# RICE POND VILLAGE

## Chapter 40B

## Neighborhood and Community Public Comments

Steve Stearns | Wed, Jan 10, 2024 | Board of Appeals Public Hearing

# RICE ROAD

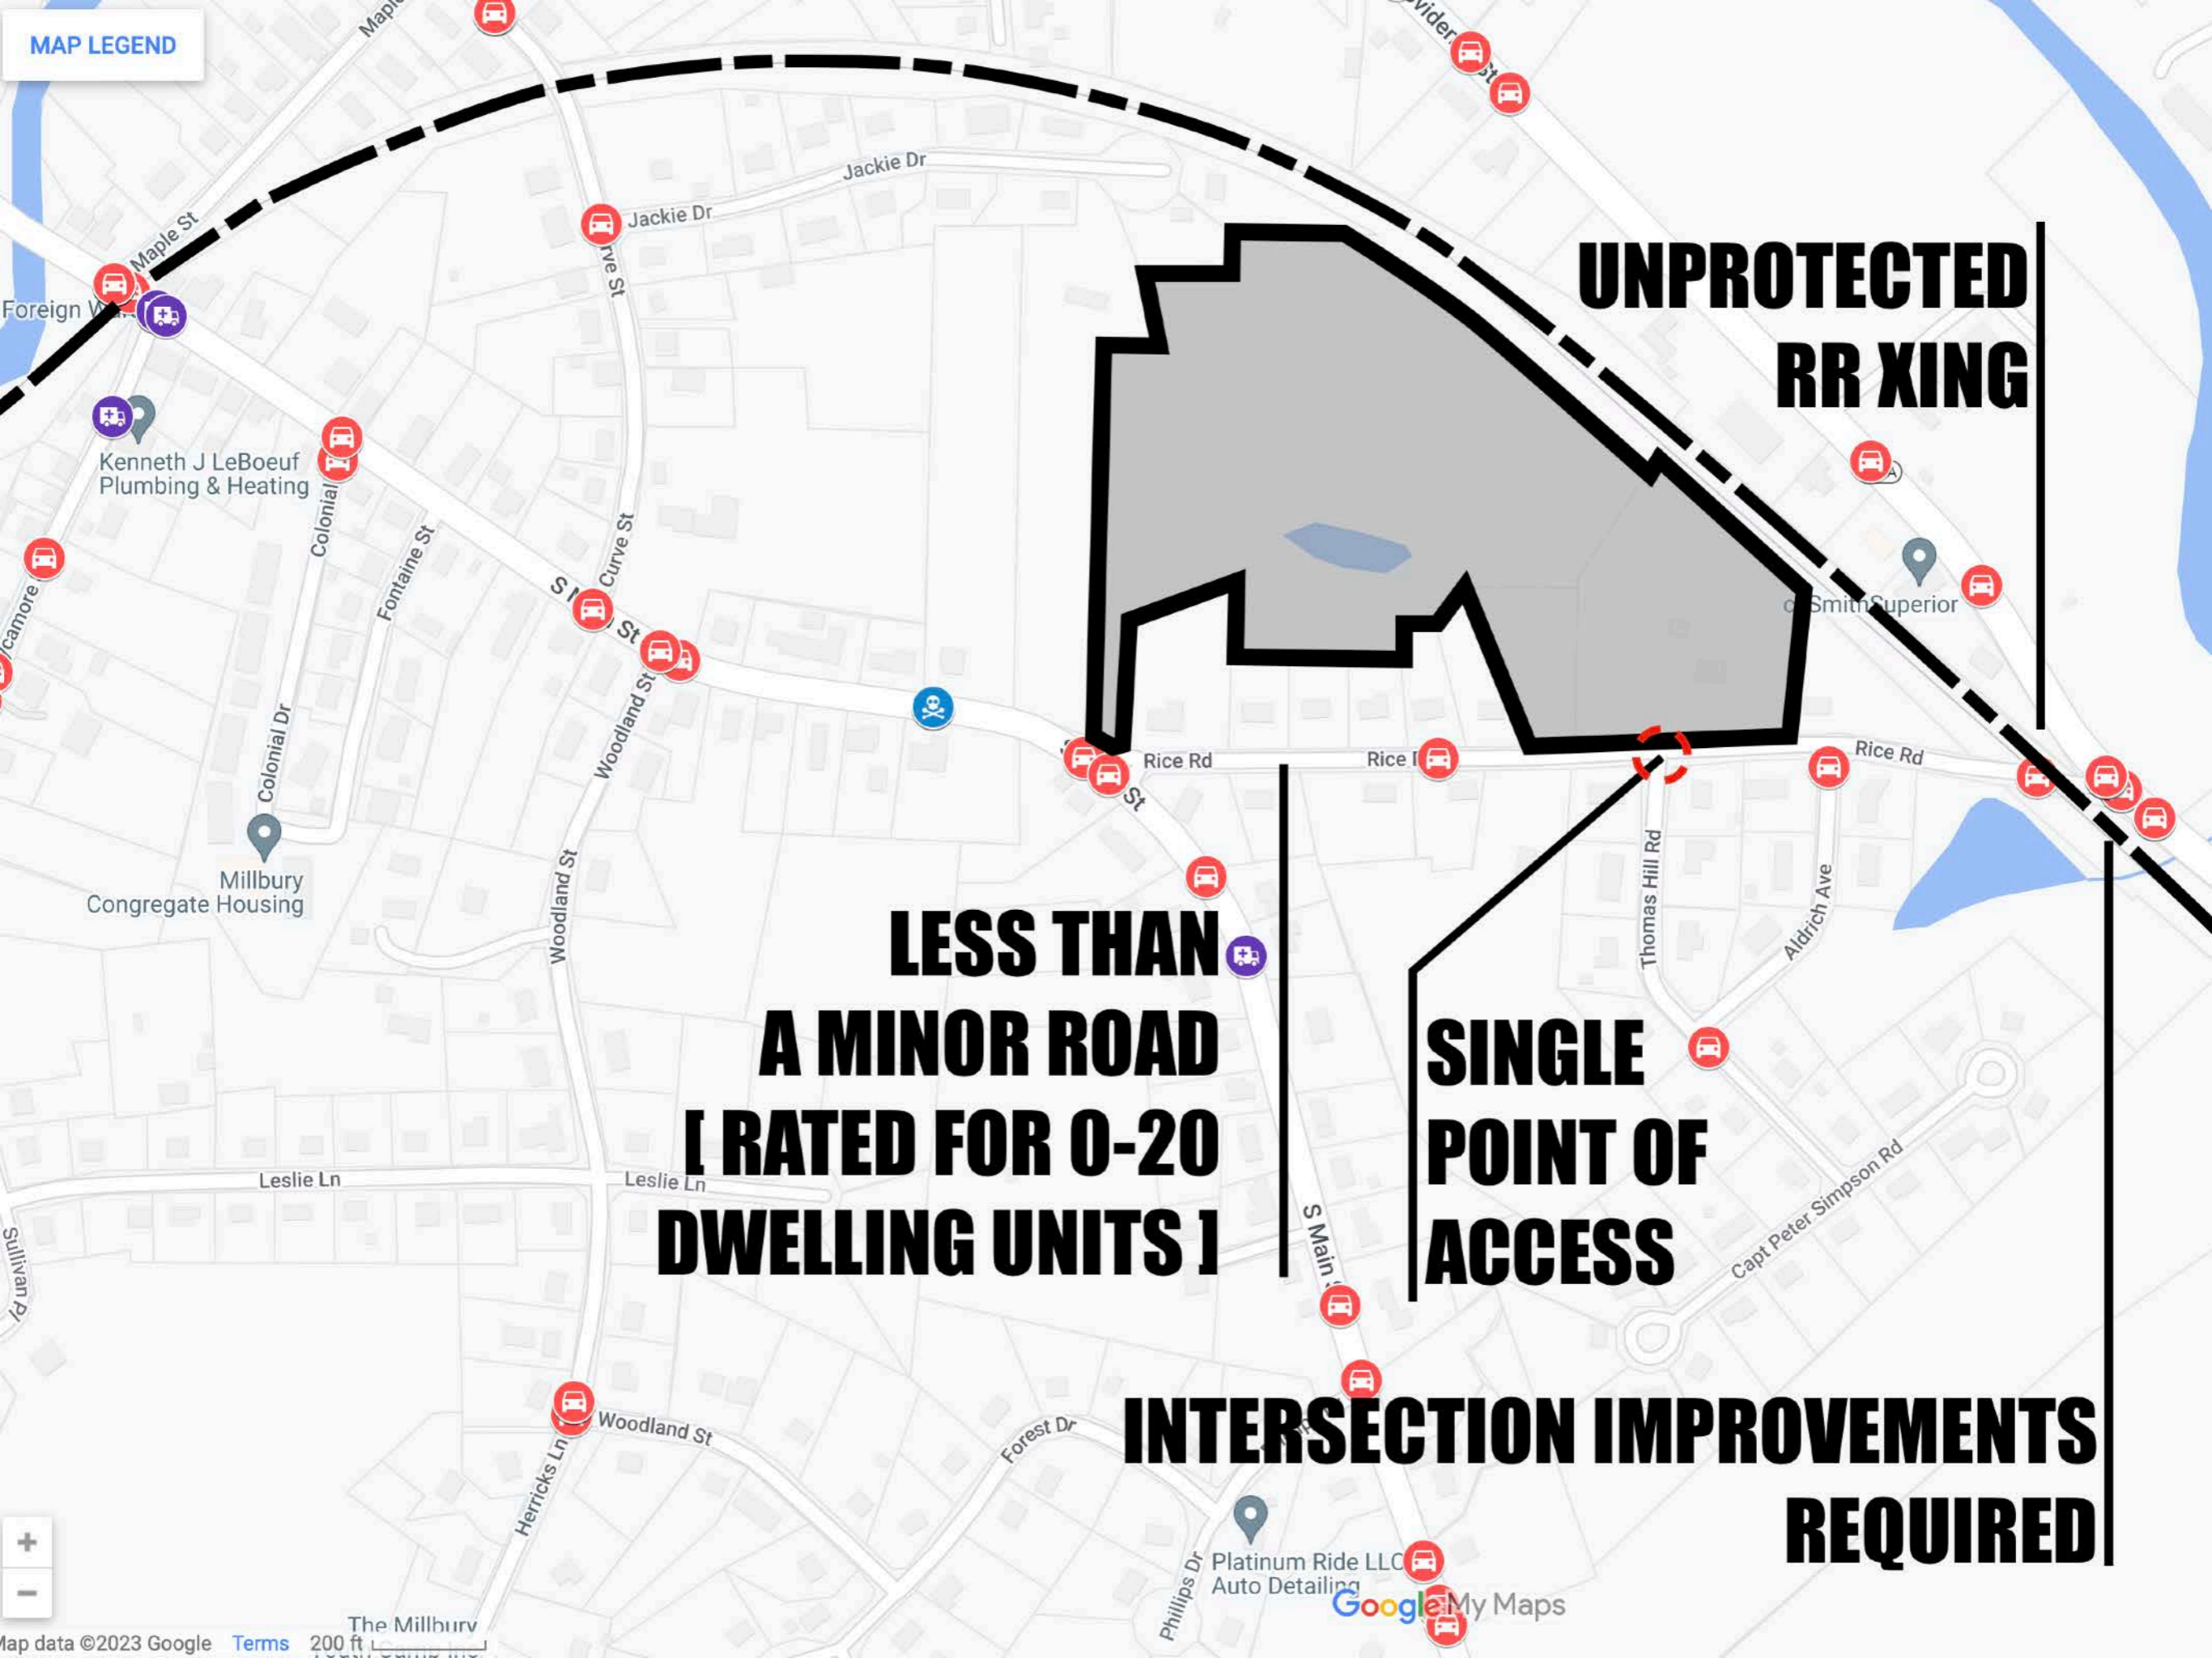
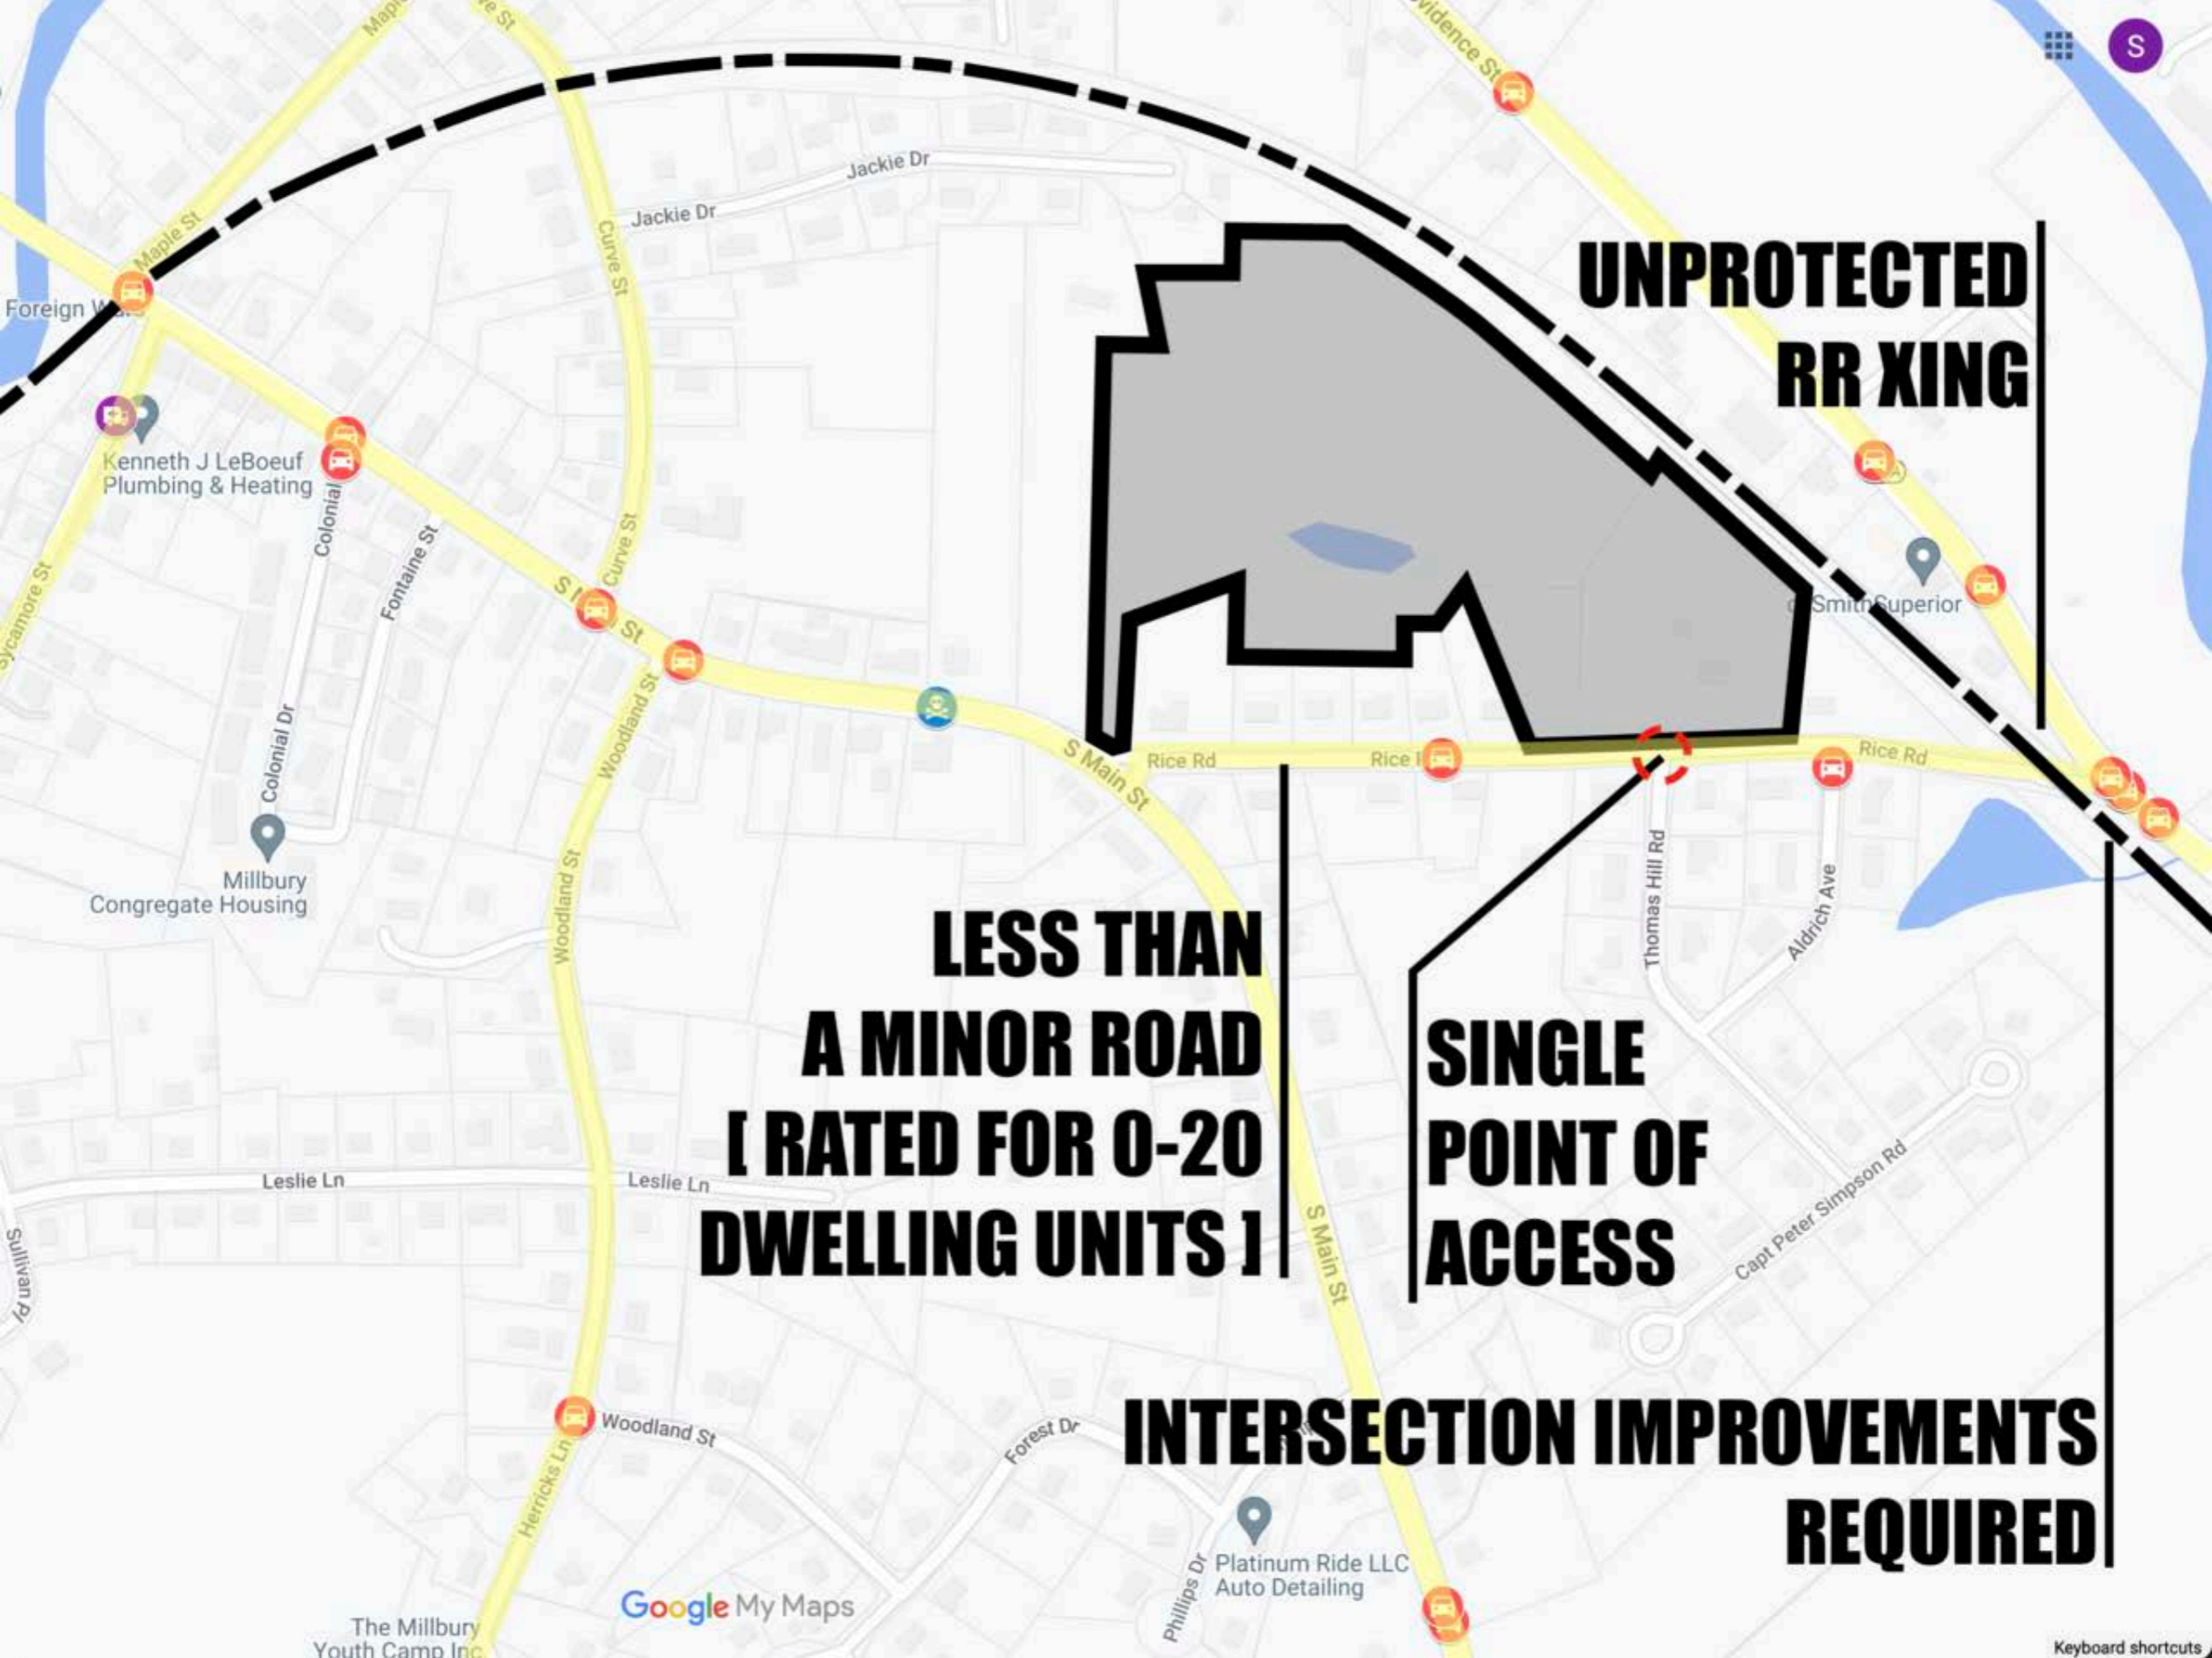
**UNPROTECTED  
RR XING**

**LESS THAN  
A MINOR ROAD  
[ RATED FOR 0-20  
DWELLING UNITS ]**

**SINGLE  
POINT OF  
ACCESS**

**INTERSECTION IMPROVEMENTS  
REQUIRED**

**UNPROTECTED  
RR XING**

**LESS THAN  
A MINOR ROAD  
[RATED FOR 0-20  
DWELLING UNITS]**

**SINGLE  
POINT OF  
ACCESS**

**INTERSECTION IMPROVEMENTS  
REQUIRED**
